**LAKE MANITOBA AND LAKE ST. MARTIN OUTLET CHANNELS PROJECT  
RESPONSE TO IAAC TECHNICAL INFORMATION REQUESTS**

**Question IAAC-59**

## QUESTION IAAC-59

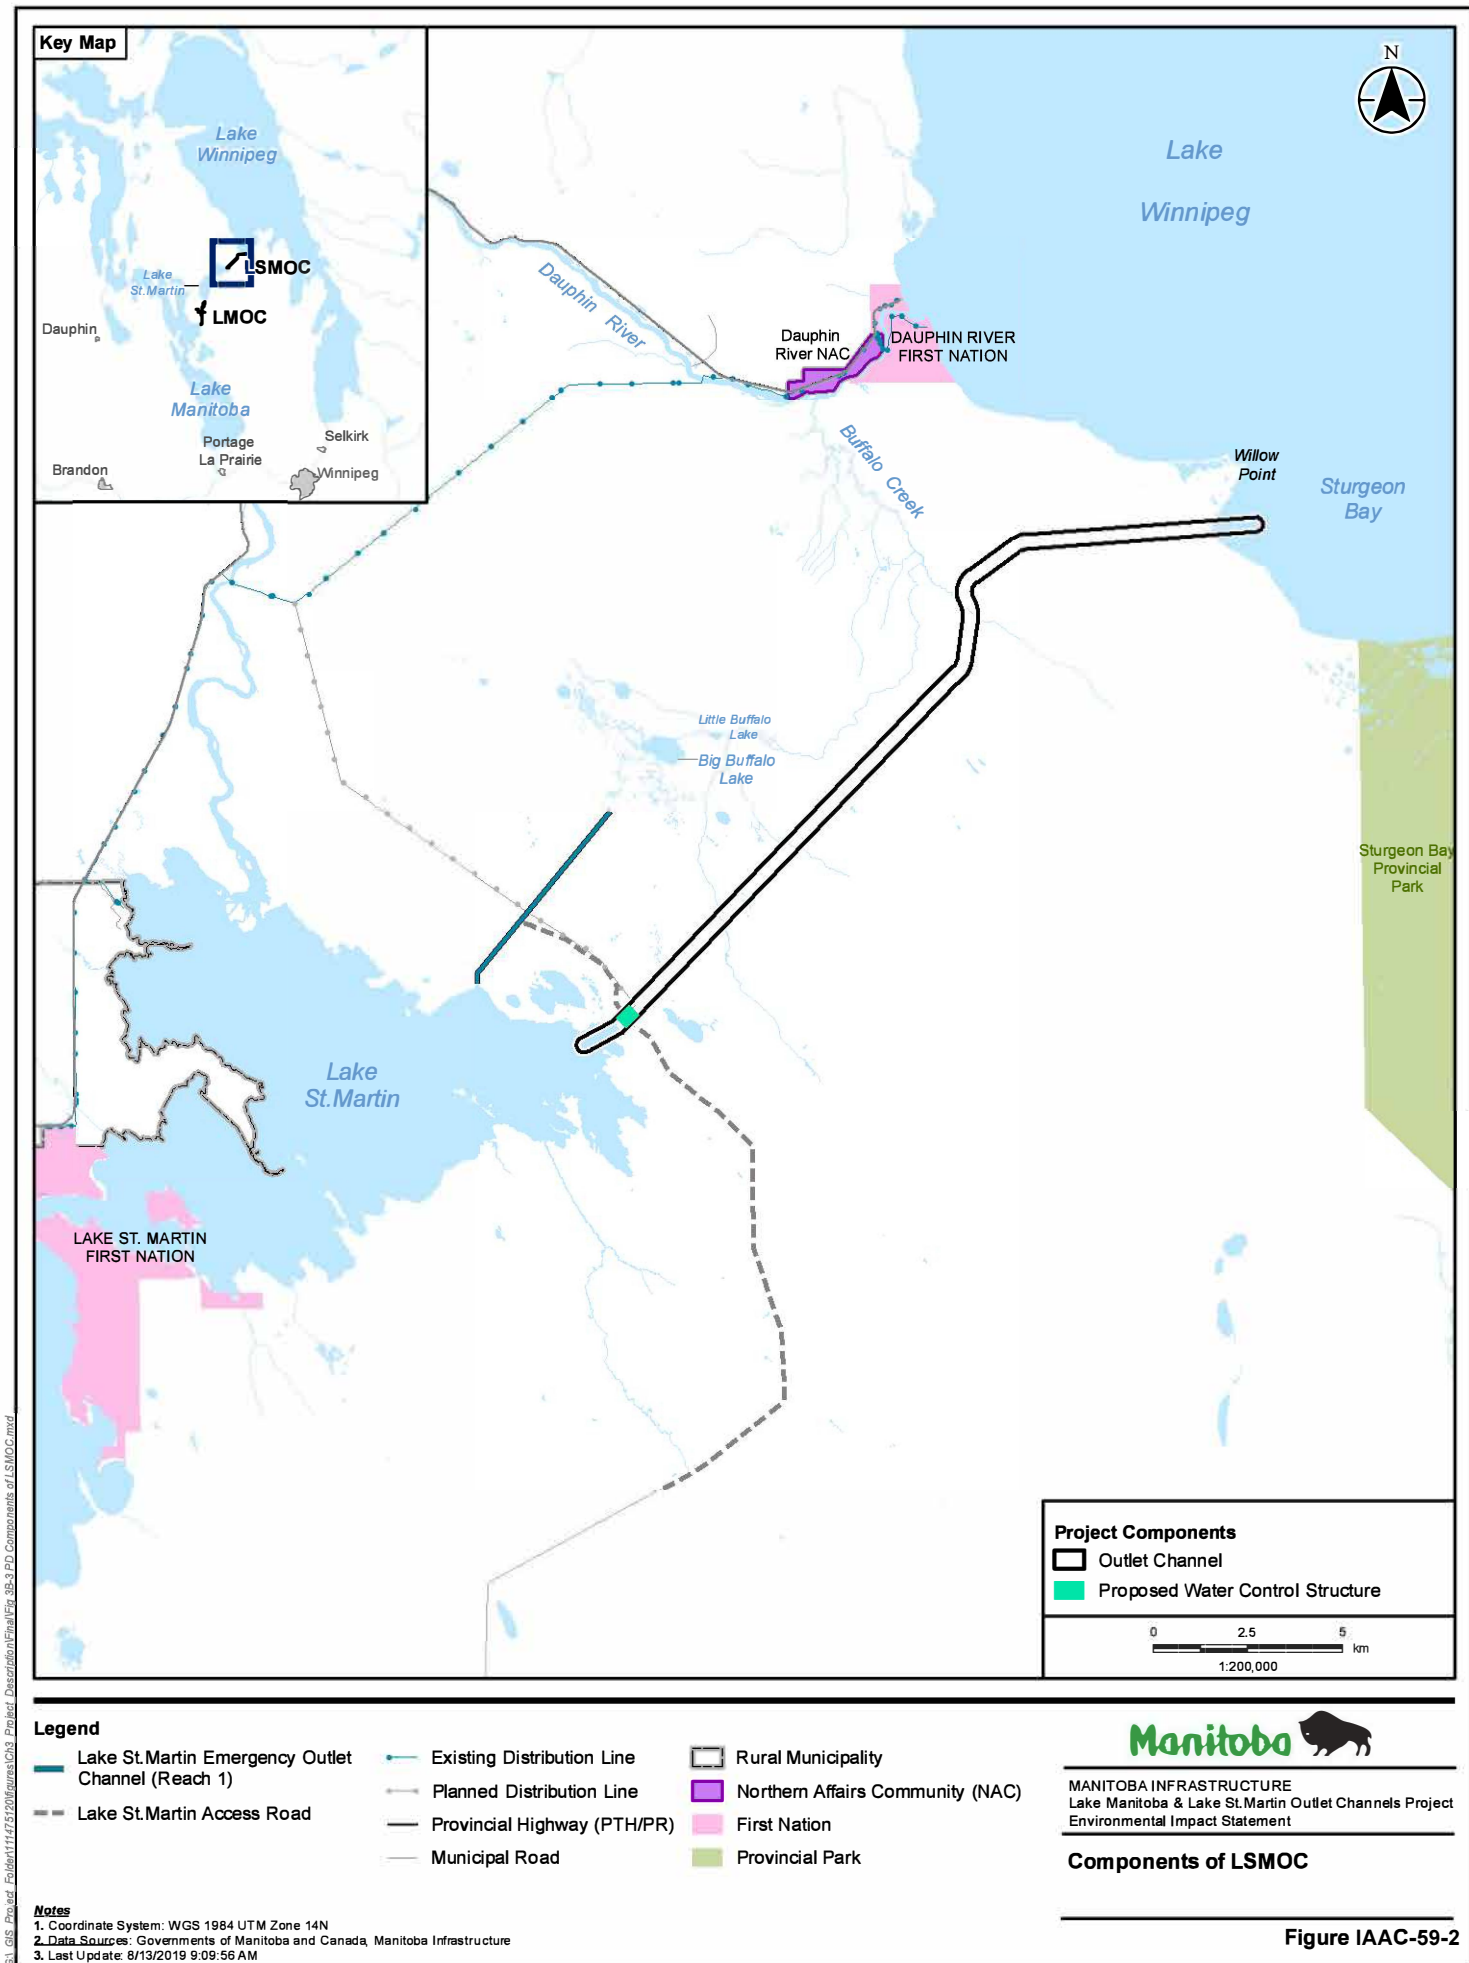
- a) In the case of a channel breach or infrastructure failure, discuss any effects to the environment that could occur due to the interaction of the project, the event and environment, e.g., interaction of infrastructure and flooding, location of effects due to project routing of water.

A breach could potentially occur if the dikes protecting the channel are broken through and water escapes the channel. Overtopping occurs when the volume of water in the channel exceeds its capacity and water flows into the surrounding area. Failure of infrastructure could include a water control structure failure or a drop structure failure. A water control structure failure would limit control of the volume of water moved. A drop structure failure could result in increased flow velocities over sharper topographic drops and create additional erosion/scour within the channel.

Appendices IAAC-59-1 and IAAC-59-2 describe potential design failures for the Lake Manitoba Outlet Channel (LMOC) (Figure IAAC-59-1) and the Lake St. Martin Outlet Channel (LSMOC) (Figure IAAC-59-2).
